Sensor Design Update

WU Kewei
2019/06/27

JTE

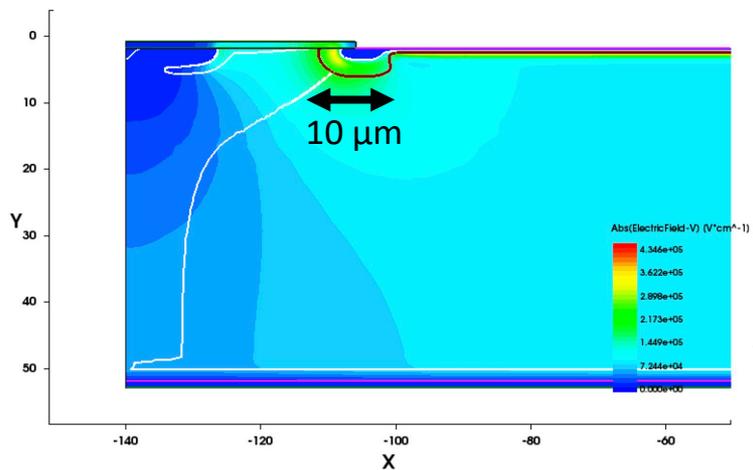
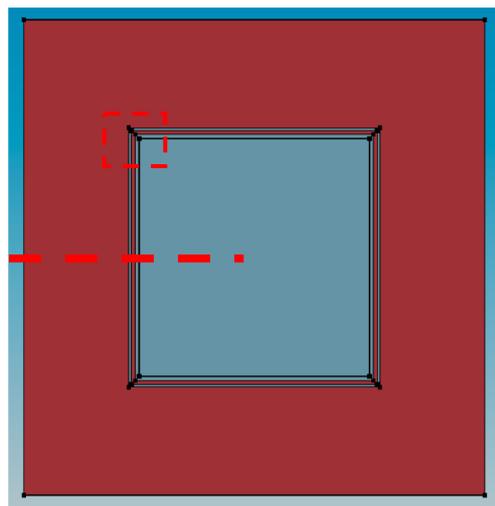
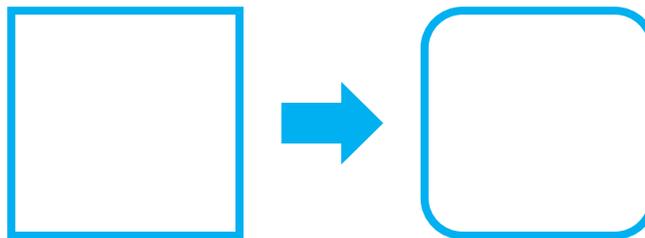
1. Our JTE width is over optimized for fill factor (10 um is too small compared with their 100 um width). After discussion with Wanli and Wan Xin, they think our sensor will breakdown early than 400 V (around 200 V) according to their rich experience on design and fabrication. They suggest us enlarge our JTE to 100 um. Good news is JTE width is the last thing that they are worried about on design.

Design Rule for lithography

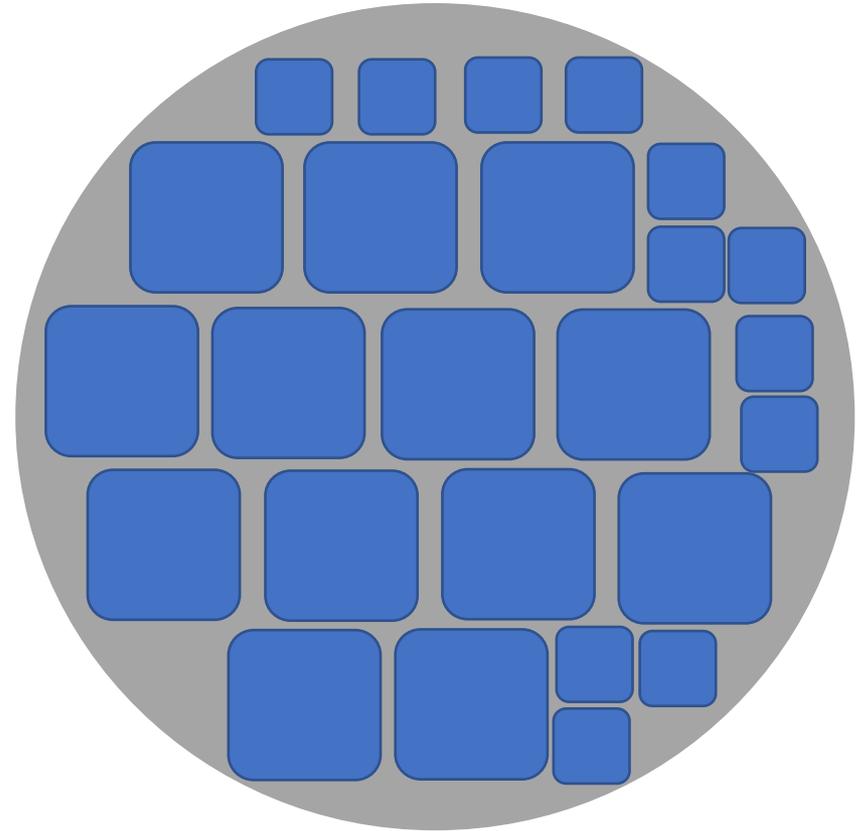
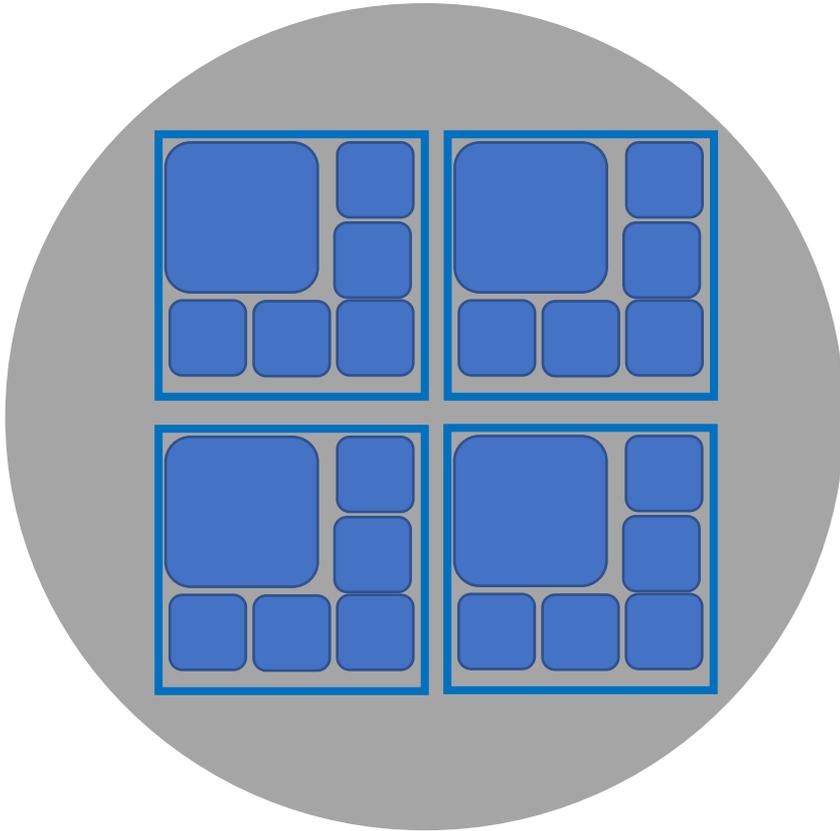
2. We can trust our simulation on TCAD. Wanli promising that their foundry has good consistency with TCAD simulation.
3. Mei need modify her layout according to Foundry's design rule for lithography. If Mei is too busy, I can draw a new one by myself.
